TDECQ, TECQ processing in IEEE 802.3db

V3.2 for comment #205 on D2.0

Pavel Zivny
Tektronix

IEEE P802.3db 100 Gb/s, 200 Gb/s, and 400 Gb/s Short Reach Fiber Task Force
TF Plenary Meeting, Nov 11, 2021

Figure 95–3—TDEC conformance test block diagram

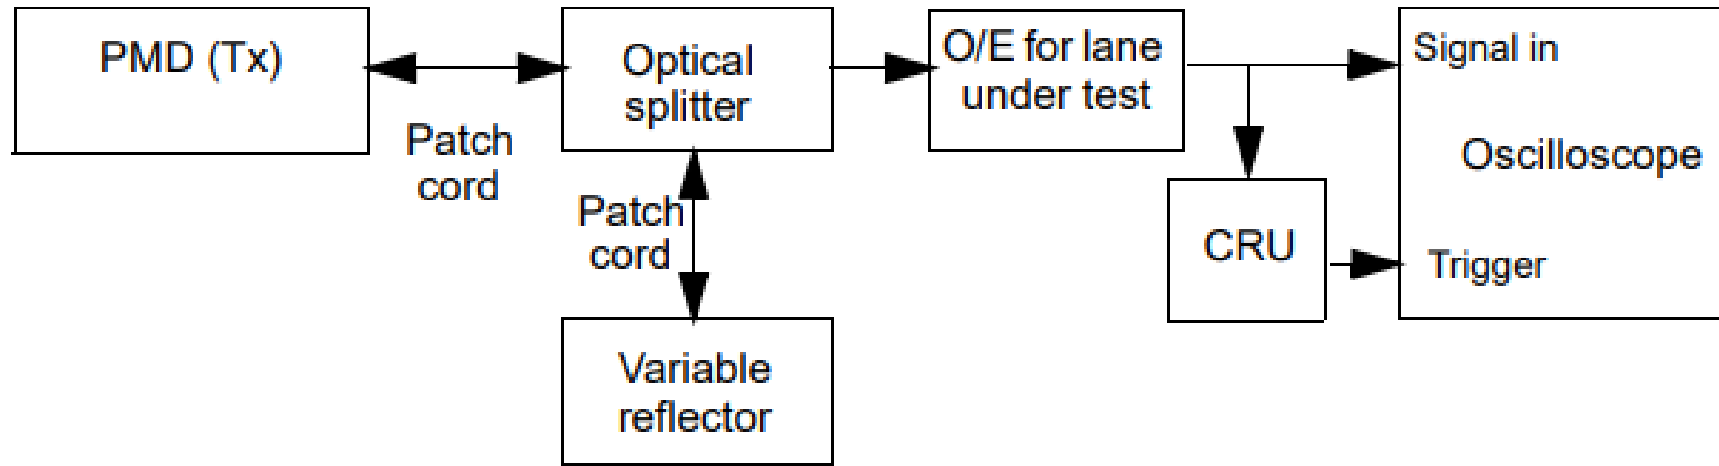
Editorial comment: Based on **Figure 95–3—TDEC conformance test block diagram; prz**
